FERGUSON TOWNSHIP PLANNING COMMISSION REGULAR MEETING AGENDA Monday, February 8, 2021 6:00 PM

A. West College Avenue Student Housing

SUBJECT: West College Avenue Student Housing Land Development Plan

PRELIMINARY LAND DEVELOPMENT PLAN

GRADING PLAN - ENLARGEMENT

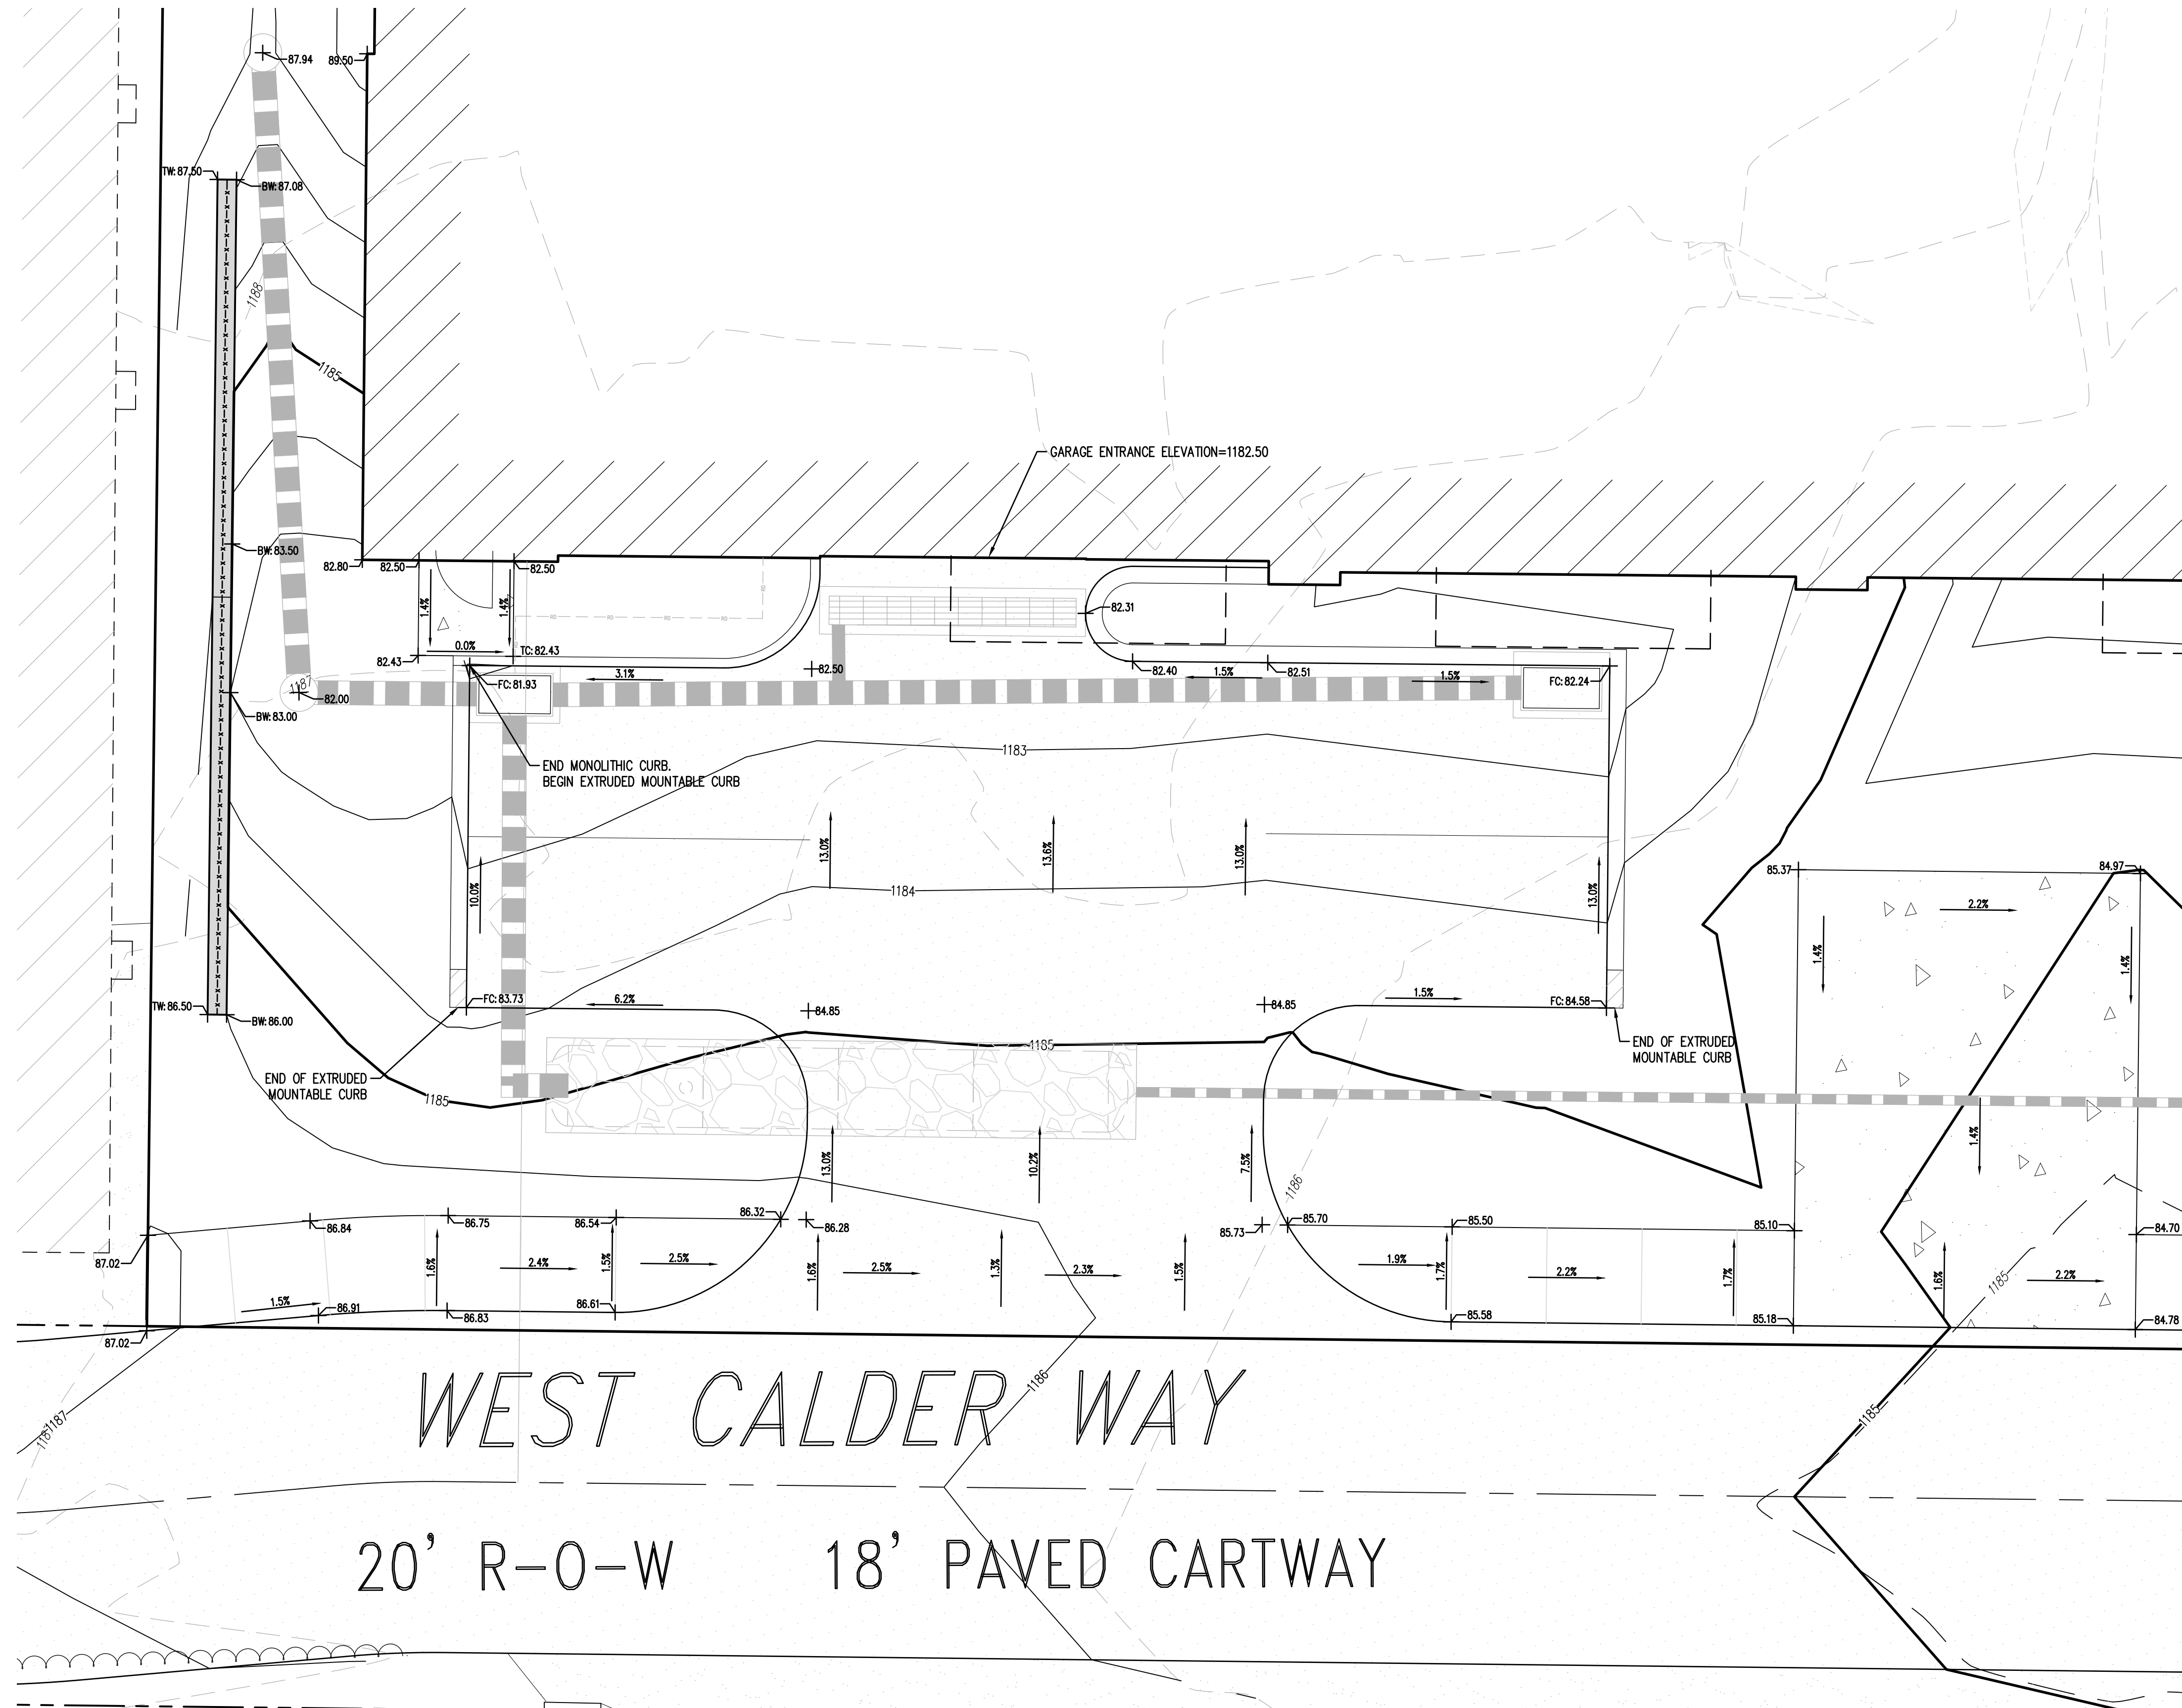
Also, the grading details illustrated on Sheets 7 and 8, all site cover conditions including landscaping located in drainage swales, and all complete roof drainage details must be part of the Stormwater Management Site Plan.

PROJECT NO.	19052
DATE	AUGUST 14, 2020
SCALE	N.T.S.
SHEET NO.	PC2

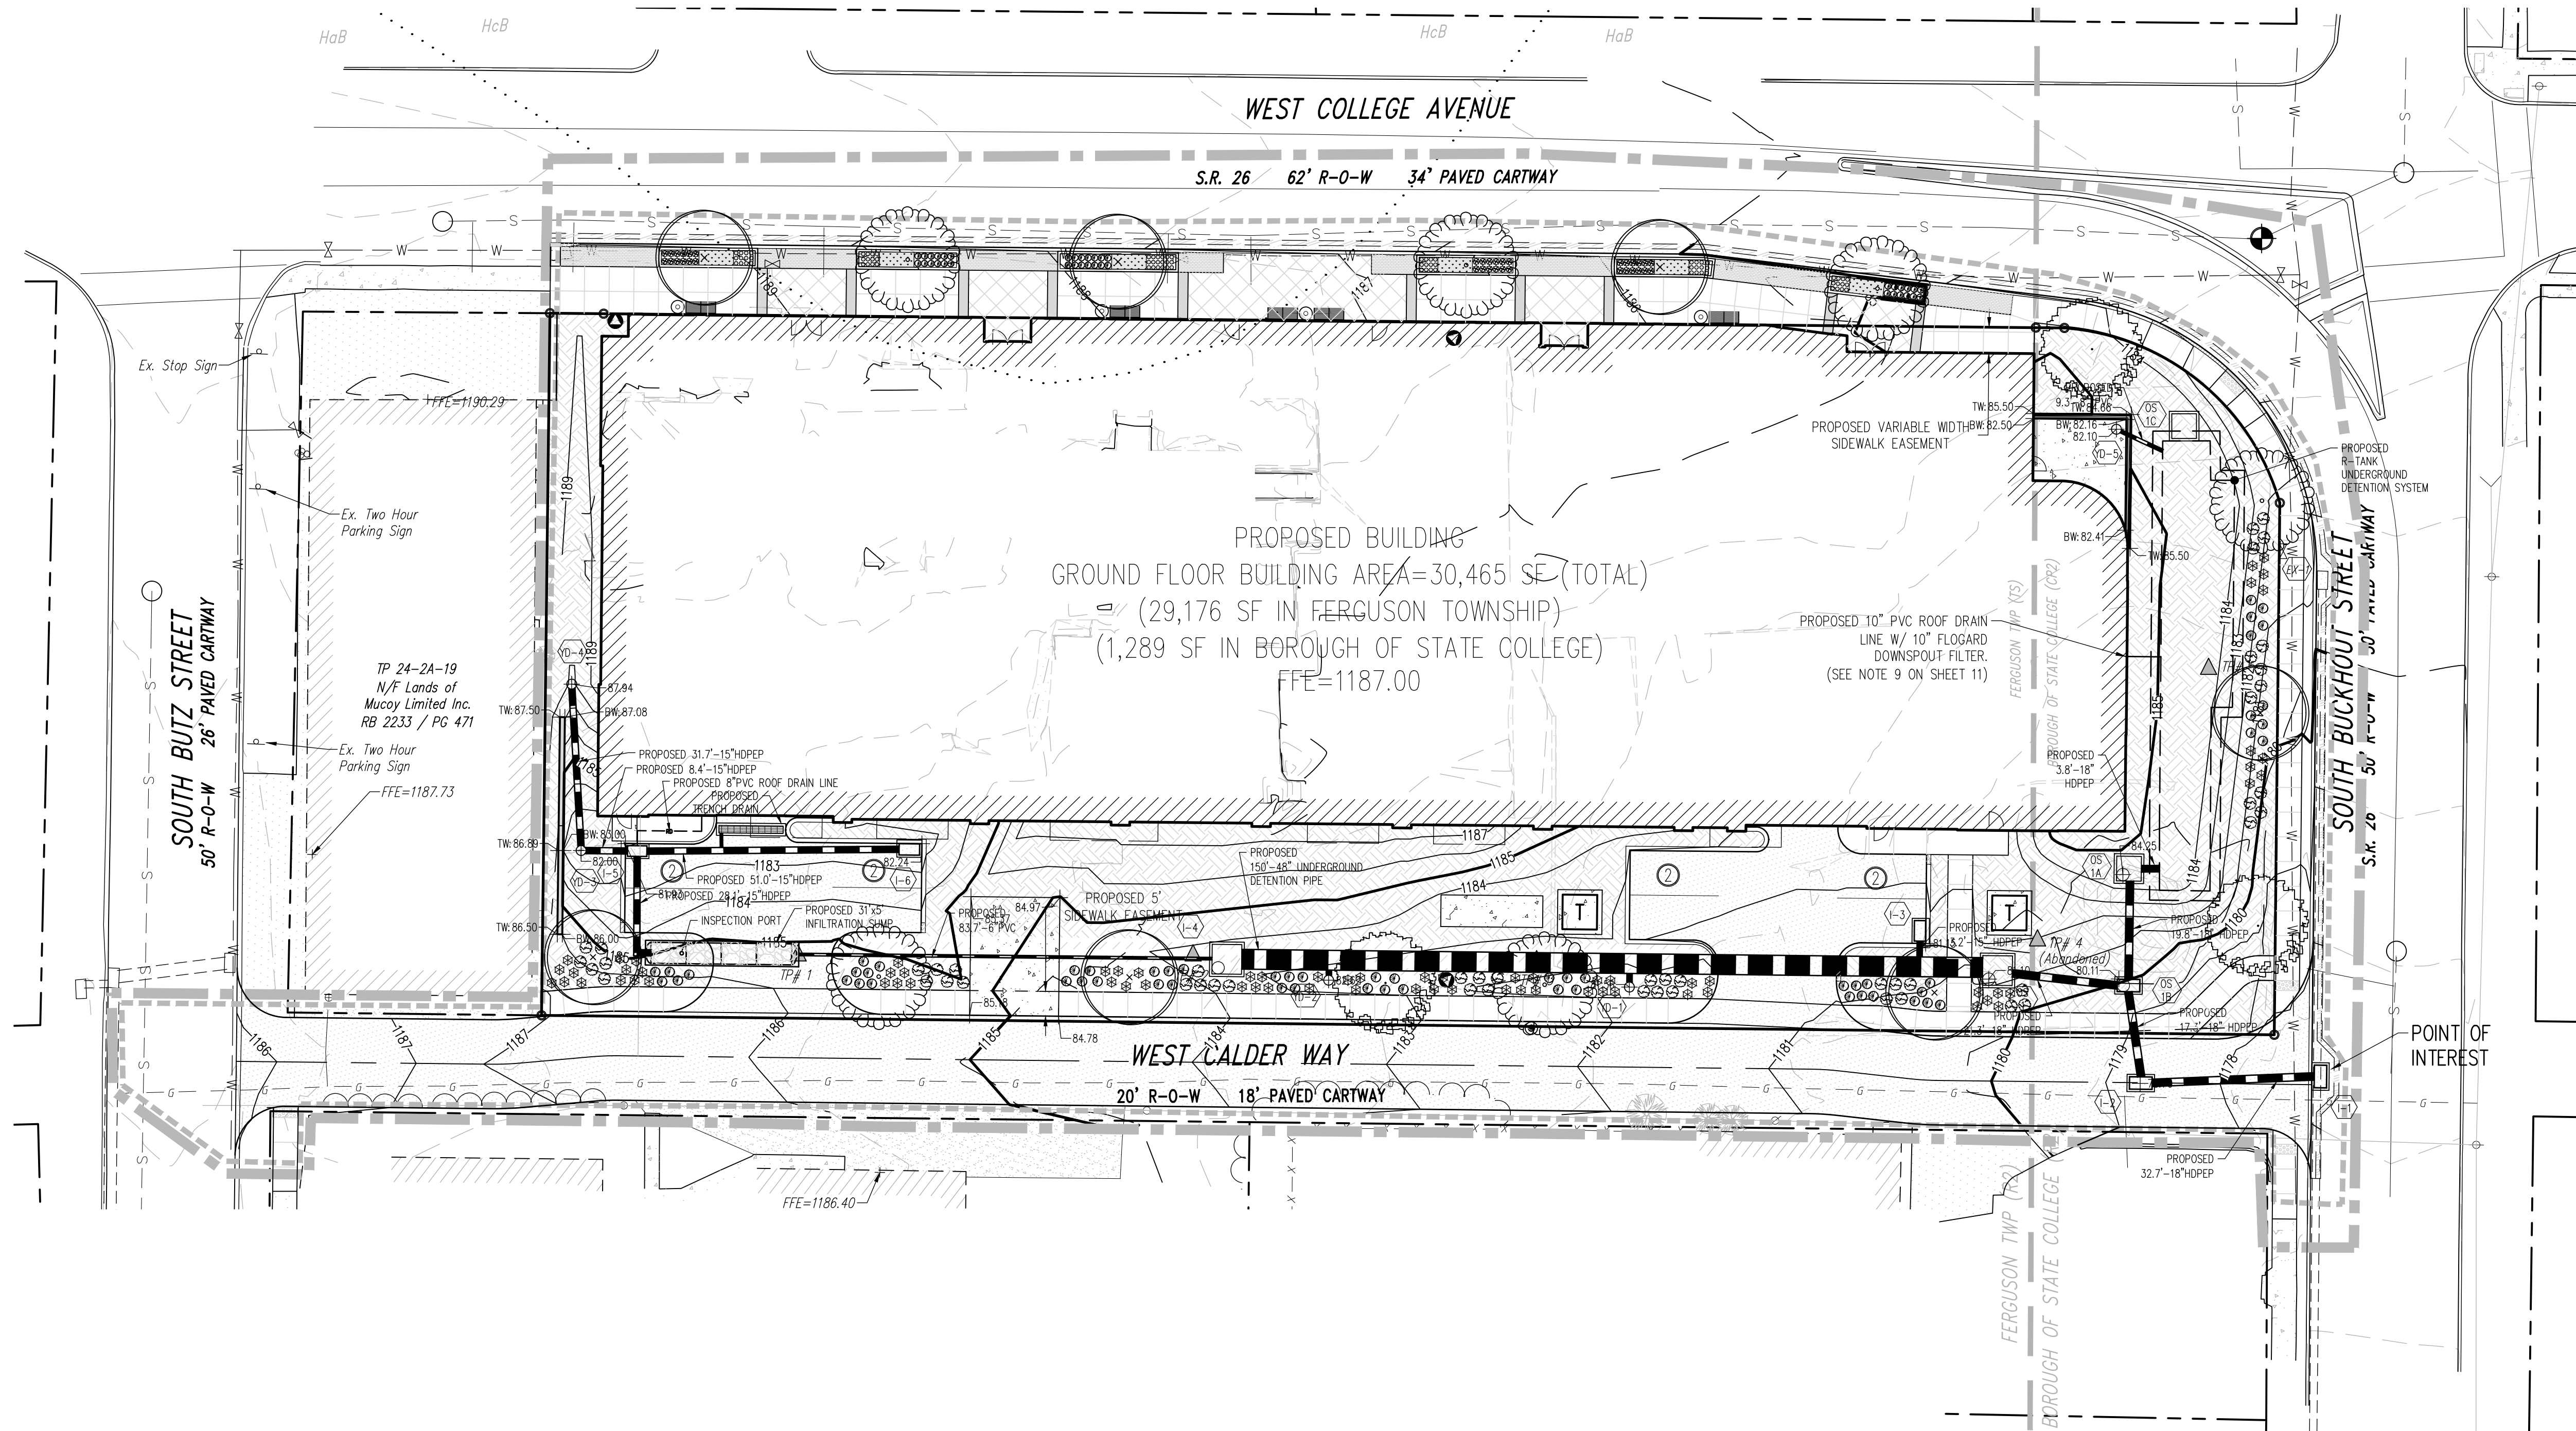
42. Newly proposed river stone area is not identified as being treated in accordance with the amended soil specification on Sheet PC2. Adjust the soil amendment volume credit and hydrologic/hydraulic analysis impacted by the associated change in runoff curve number for this area.

PROJECT NO.	19052
DATE	AUGUST 14, 2020
SCALE	1"=20'
SHEET NO.	ES1

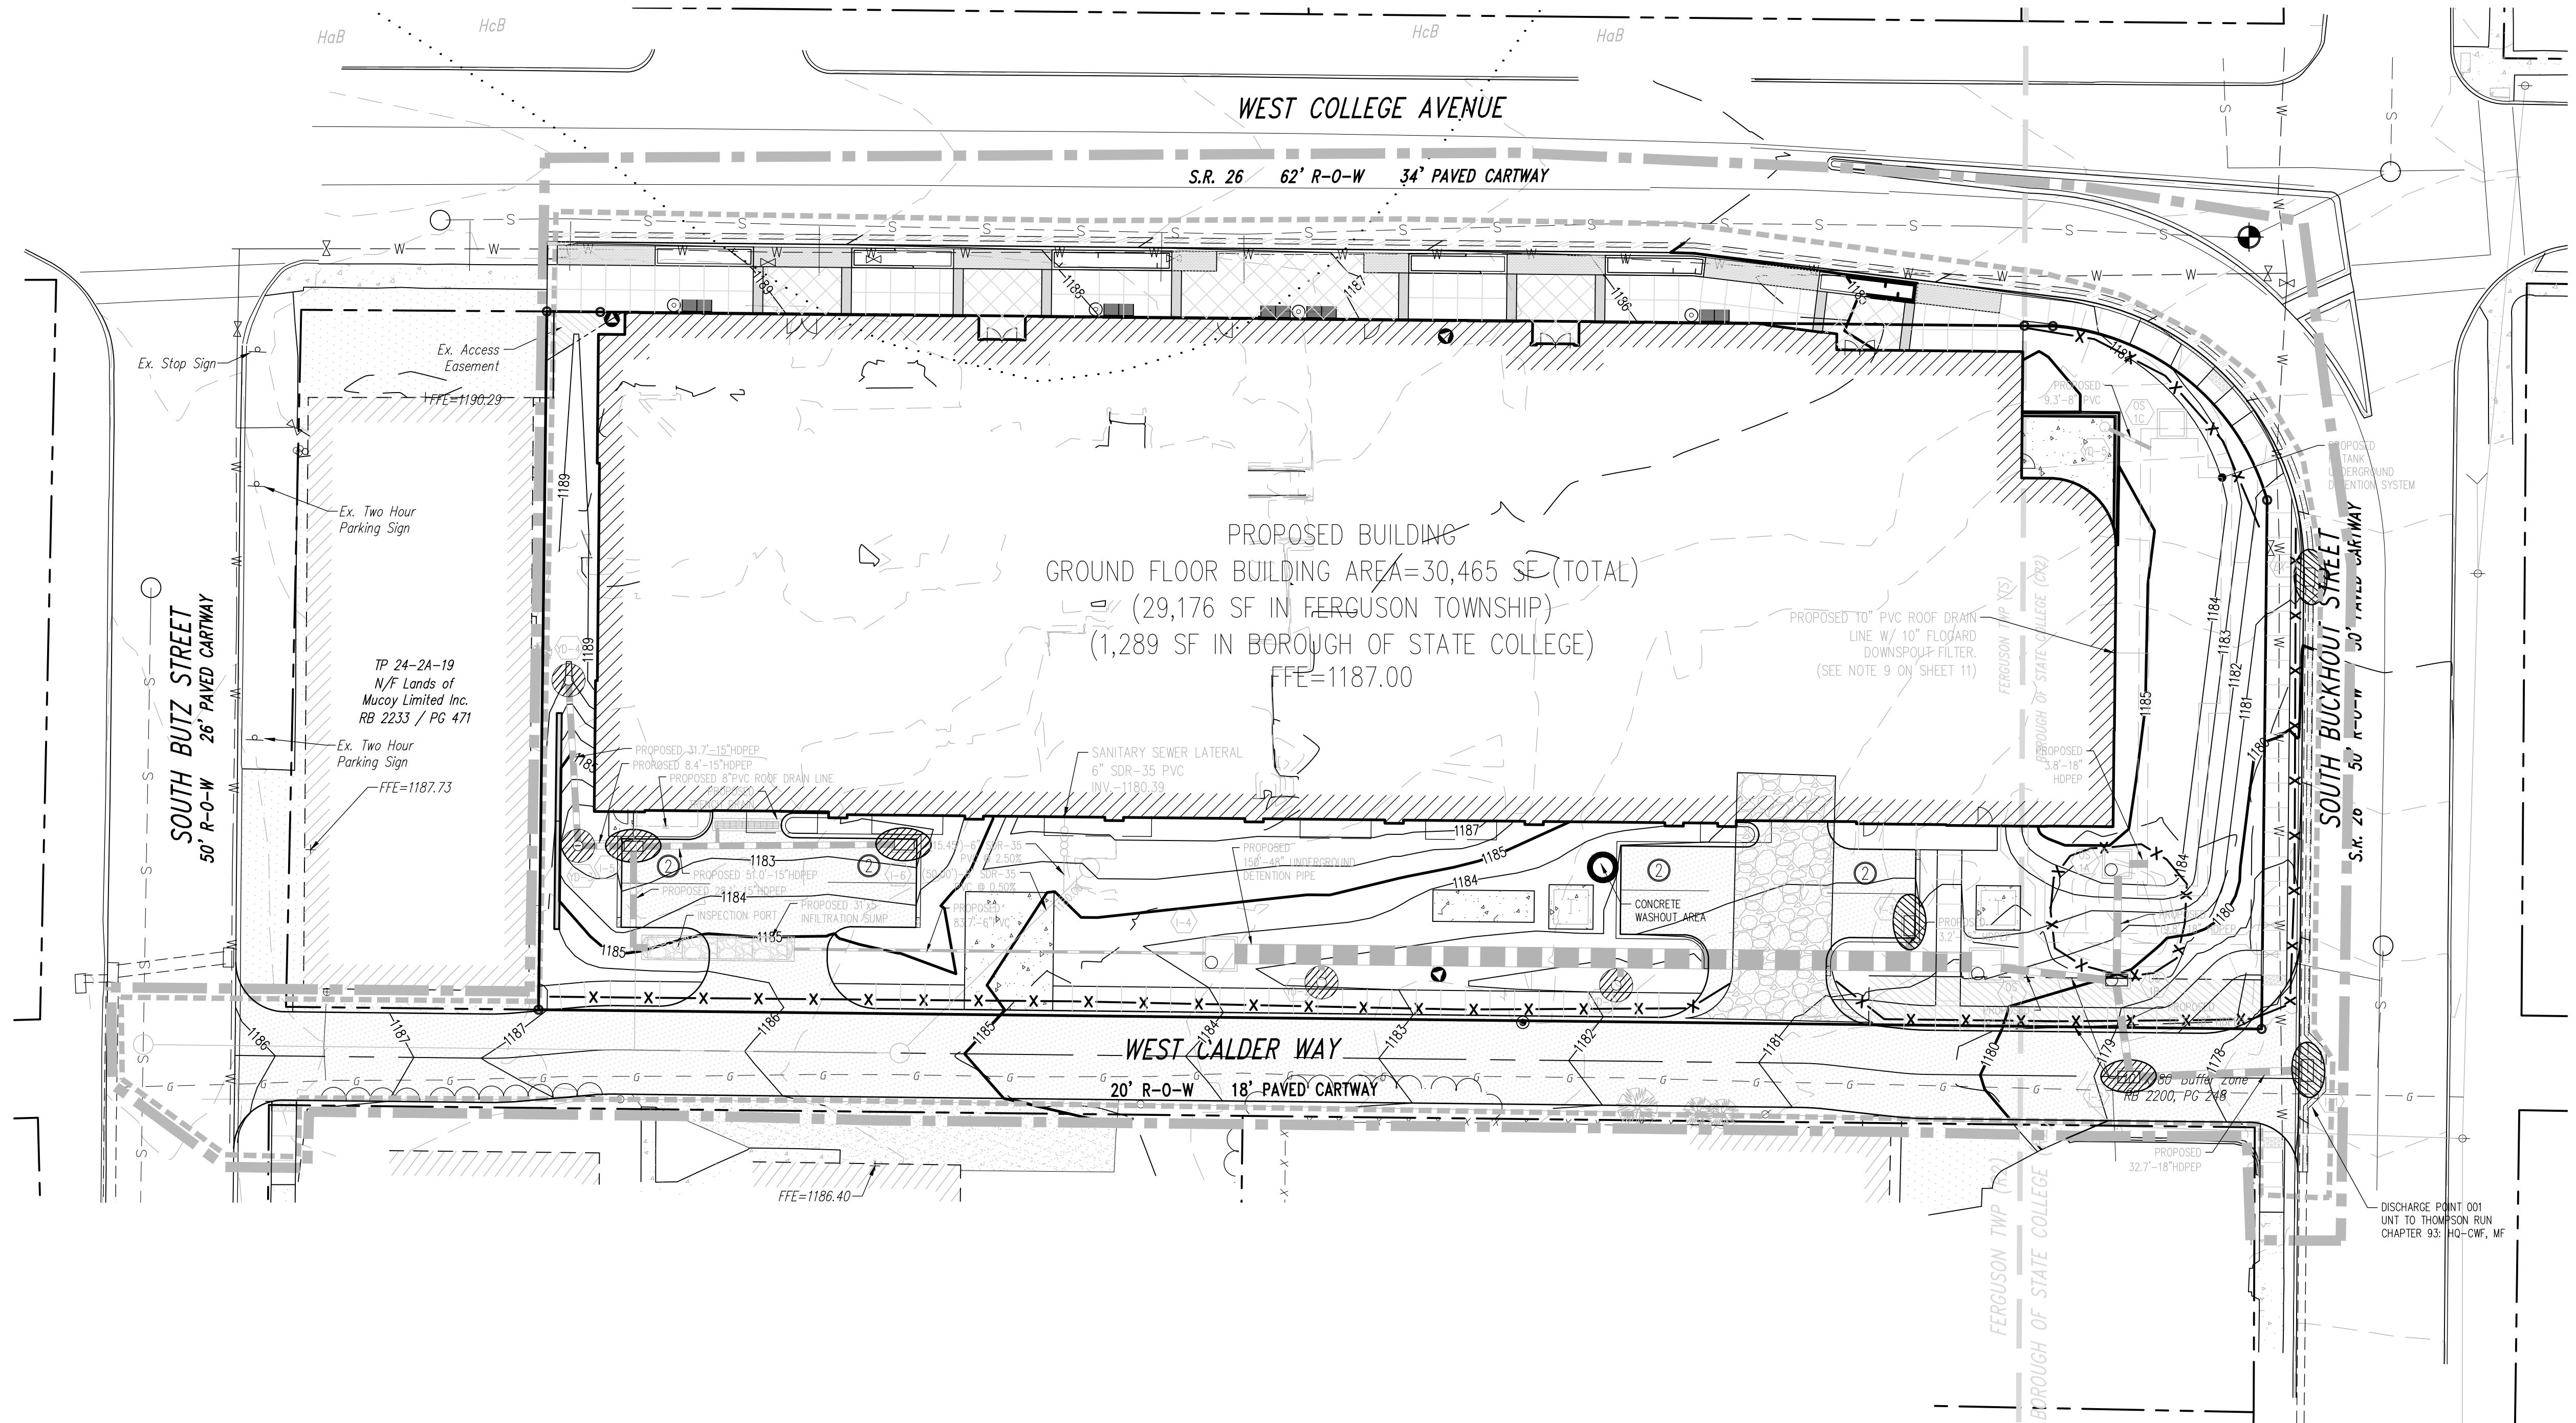
2021 02 02 Comment: Revisions were made to the Critical Stages of Construction notes on Sheet ES1 and a note was added to Sheet 4 identifying that the sinkhole repair detail is to be included as part of the Stormwater As-built plans. This information must also be represented on the Stormwater Management Site Plan Drawings.
